**SECTION 4.55(1A) MODIFICATION APPLICATION – SSD 9351535
JOHN HUNTER HEALTH AND INNOVATION PRECINCT, LOOKOUT DRIVE, NEW LAMBTON HEIGHTS**

This application has been prepared by Ethos Urban on behalf of Health Infrastructure NSW (HI) pursuant to section 4.55(1A) of the *Environmental Planning and Assessment Act 1979* (EP&A Act) to modify Development Consent SSD 9351535 relating to the John Hunter Health and Innovation Precinct (herein referred to as JHHIP).

This modification seeks approval for tree clearance in a portion of the site that always required to be cleared of vegetation to support approved construction works.

Figure 2 Tree clearing removed from RP2J project
Source: Umwelt

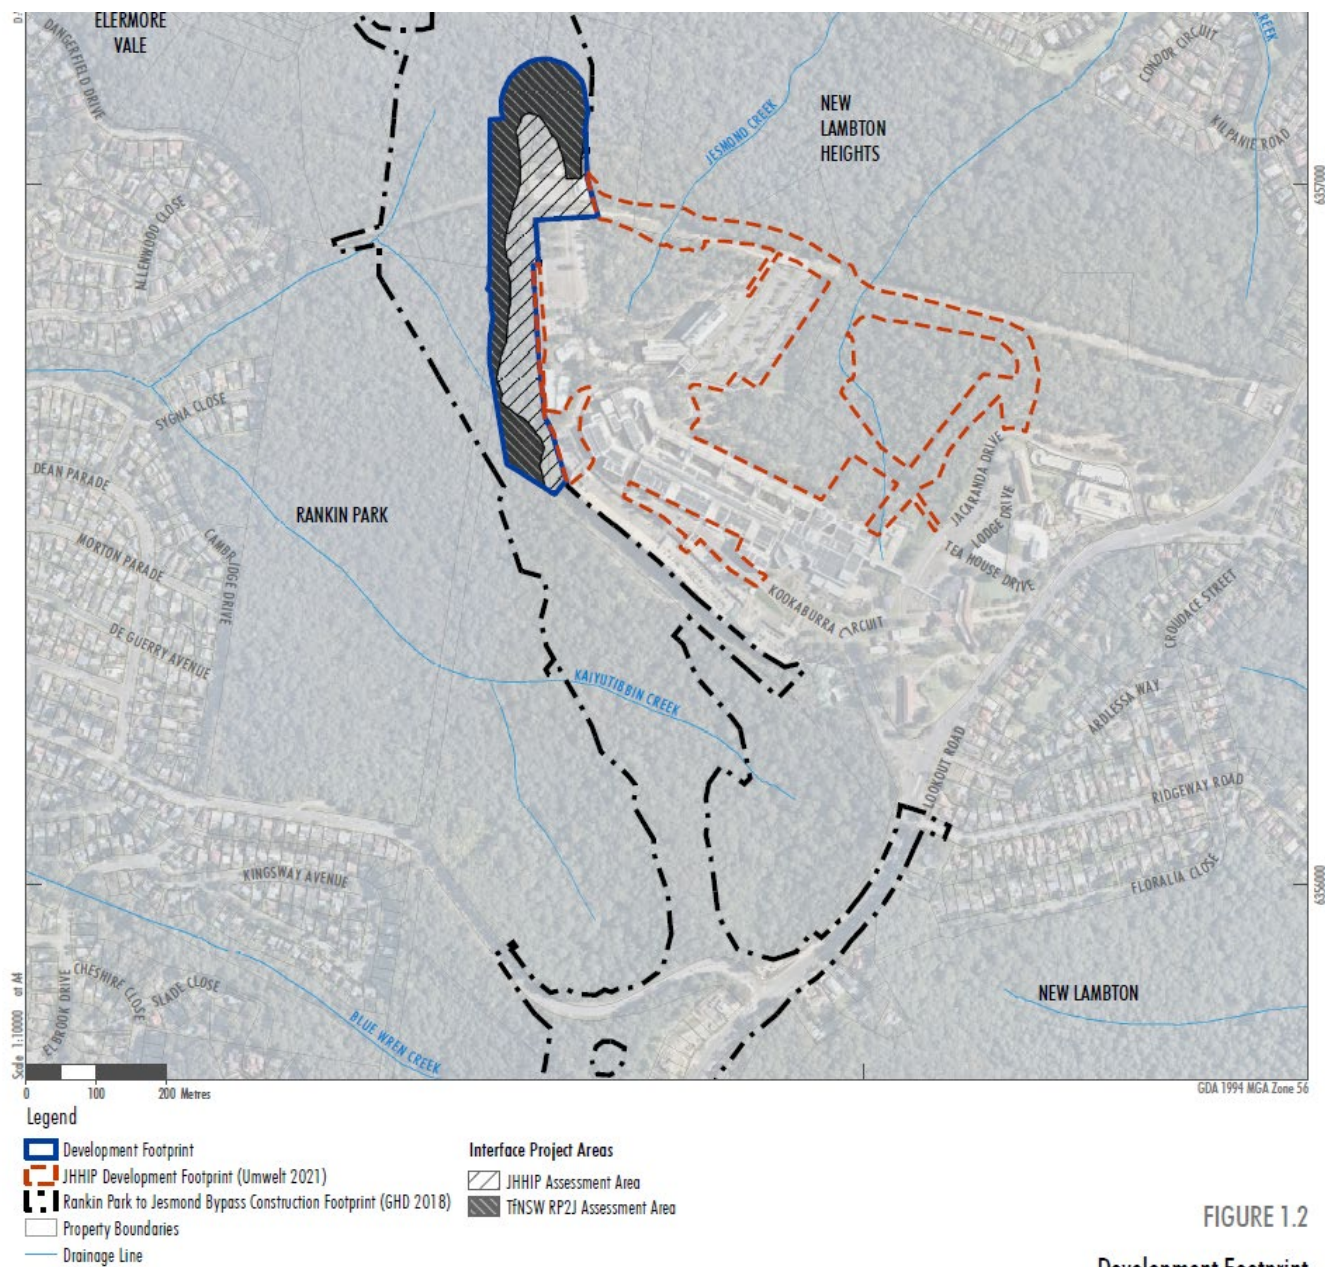
- The relevant tree clearing in the area identified within **Figure 2** is now not being undertaken for the purpose of the RP2J project. However, the tree clearing is required to enable the works approved in the JHHIP SSD. The modification seeks to allow clearance of this area for the approved purpose, being works for the JHHIP project.
- TfNSW have undertaken a "consistency test" of their SSI approval, confirming that a modification of the SSI approval is not required.

This JHHIP modification application therefore seeks to incorporate tree removal and environmental clearing of the interface area under SSD 9351535, which means tree and environmental clearing that is the subject of this JHHIP modification application no longer form part of the RP2J project.

Figure 4 The extent of clearing previously approved in the SSI 6888 consent (purple) within the interface area.

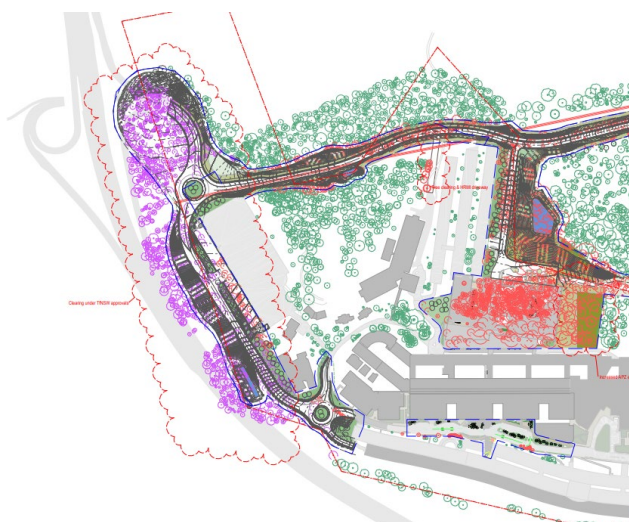
The Acute Services Building and refurbishment of hospital facilities at JHHIP (SSD 9351535) included two phases of vegetation clearing (being Phase 1 and 2). This modification seeks to include an additional area to the west of the existing approved area, which represents the interface between the JHHIP project and RP2J (herein referred to as Phase 3) to allow Health Infrastructure to clear this vegetation.

The area subject to clearing is approximately 5.45 ha in area. **Figure 4** and **Figure 5** below shows the tree clearing proposed between SSI 6888 and SSD 9351535. Revised Architectural Drawings and Landscape Drawings are provided at **Attachment A** and **B** respectively.

Figure 5 The extent of clearing proposed to be incorporated into the SSD 9351535 consent (blue) within the interface area.
